TRANSPORT IMPACT STATEMENT (CHANGE APPLICATION)
PROPOSED RESIDENTIAL DEVELOPMENT
23-25 SAMMELLS DRIVE CHERMSIDE
(RESPONSE TO INFORMATION REQUEST DATED 15 JULY 2026)

BCC DS
RECEIVED
03/08/2026
APPLICATION REF
A007043813

30 JULY 2026
RTeref: 26185

ATTACHMENT D – SWEEP PATHS OF A B99 DESIGN VEHICLE

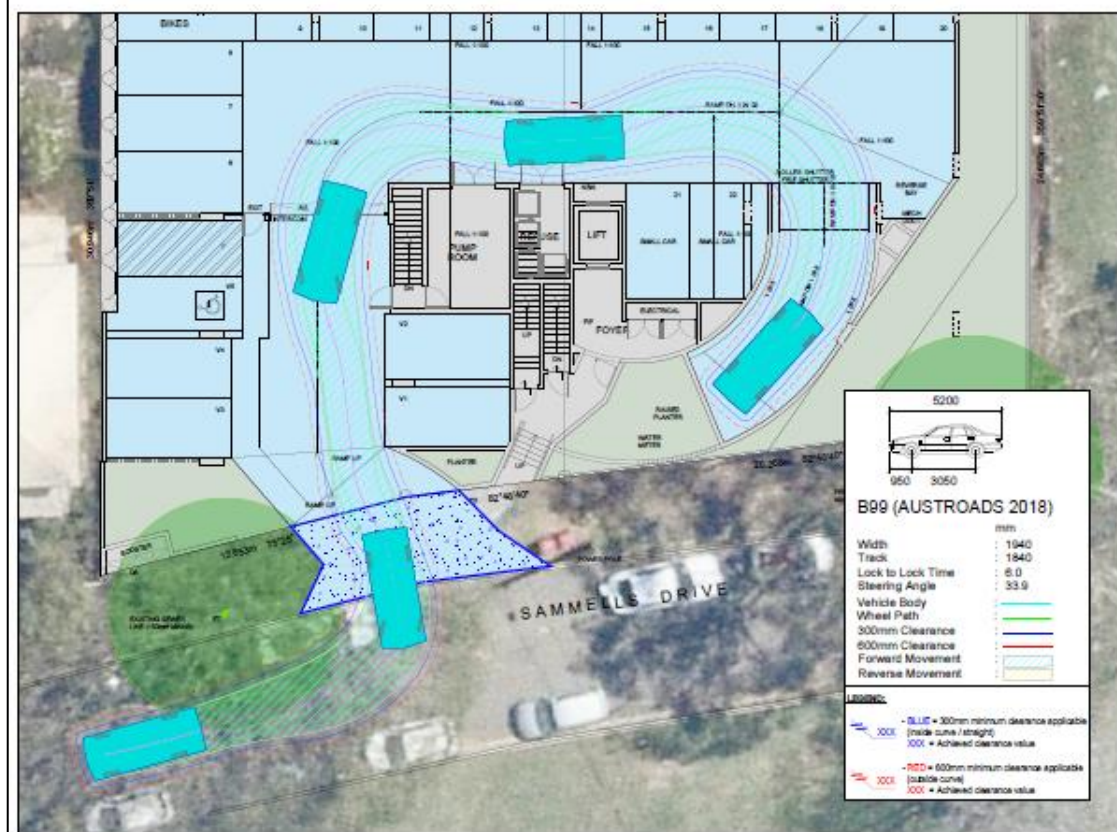
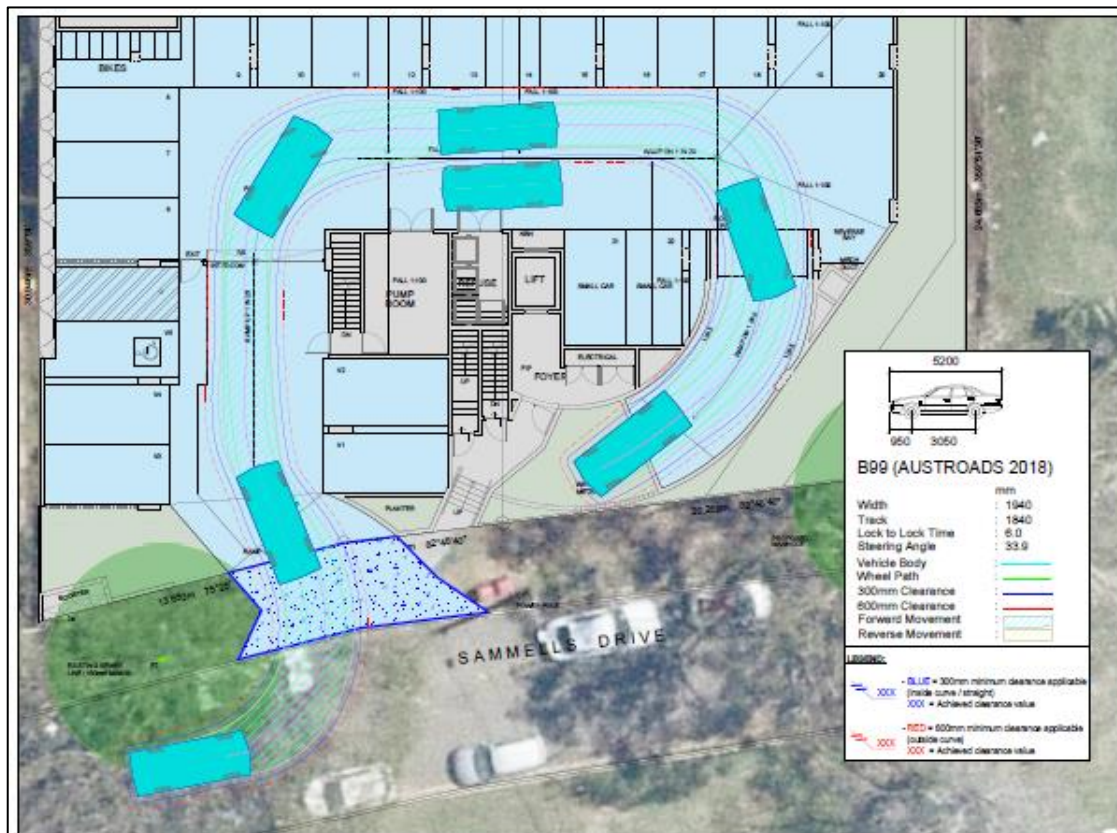
- 1. Traffic**
 - 1.1. Address any required on-street parking changes required for RCV access.**
 - 1.2. Review ramp gradients/widths.**
 - 1.3. Review parking and manoeuvring changes.**
 - 1.4. Provide RPEQ certified swept path analysis for a 10.24m RCV.**
 - 1.5. Summarise review in supporting RPEQ Traffic Statement.**

- 1.2 The proposed ramp gradients and widths have been reviewed and are considered compliant with the relevant requirements of AS2890.1:2004. The ramp provides a minimum width of 3.9m and a maximum grade of 1:5, with 1:10 transition grades provided at each end. Swept path analysis provided in Attachment D demonstrates satisfactory manoeuvring by a B99 design vehicle. The proposed ramp management arrangements are shown in Attachment F.

The ramp provides a minimum width of 3.9m and a maximum grade of 1:5, with 1:10 transition grades provided at each end. Swept path analysis provided in Attachment D demonstrates satisfactory manoeuvring by a B99 vehicle. It is noted however that RTE recommends that kerbs not be provided along the edges of single lane curved ramps and the architect has been advised to remove them.
